Access Compliance Report

Public Rights-of-Way

Intersection ID: N/A	Main Street: VILLAGE_WALK_RD	Cross Street: HOUSTON_FIELD_CT	Location: NW
ADA ID: 34EB52FAACB8	Ramp Type: Perp	Initial Pass/Fail: Fail	Overall Compliance: No
			Severity Score: 21.25

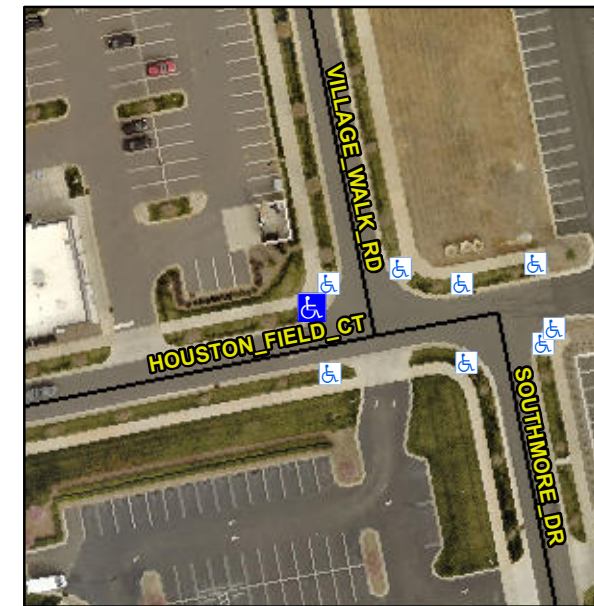
Not Found, R304.5.1, R304.5.3

Compliance	Description	Data	Compliance	Description	Data
N/A	Ramp Length (in)	95.0	Yes	Ramp Slope (%)	6.8
No	Ramp Width (in)	38.0	No	Ramp XSlope (%)	5.5
N/A	Flare Type LT	N/A	N/A	Flare Type RT	N/A
N/A	Flare Slope LT (%)	N/A	N/A	Flare Slope RT (%)	N/A
N/A	Flare Traversable LT?	N/A	N/A	Flare Traversable RT?	N/A
N/A	Landing Length (in)	N/A	N/A	DWS Provided?	N/A
N/A	Landing Width (in)	N/A	N/A	DWS Contrast?	N/A
N/A	Landing Slope (%)	N/A	N/A	DWS Length (in)	N/A
N/A	Landing X Slope (%)	N/A	N/A	DWS Full Width?	N/A
N/A	Landing Curb? (Y/N)	N/A	N/A	DWS Offset (in)	N/A
N/A	Shared Landing?	N/A			
N/A	Gutter Ponding?	N/A	N/A	Gutter Slope (%)	N/A
N/A	Gutter Lip Ht (in)	N/A	N/A	Gutter X Slope (%)	N/A
N/A	Painted X Walk1?	No	N/A	Painted X Walk2?	N/A
	X Walk 1 Direction	To S		X Walk 2 Direction	N/A
N/A	X Walk 1 Width (in)	N/A	N/A	X Walk 2 Width (in)	N/A
	X Walk 1 Slope (%)	1.5		X Walk 2 Slope (%)	N/A
	X Walk 1 X Slope (%)	5.6		X Walk 2 X Slope (%)	N/A

Remove & Replace Entire Ramp.
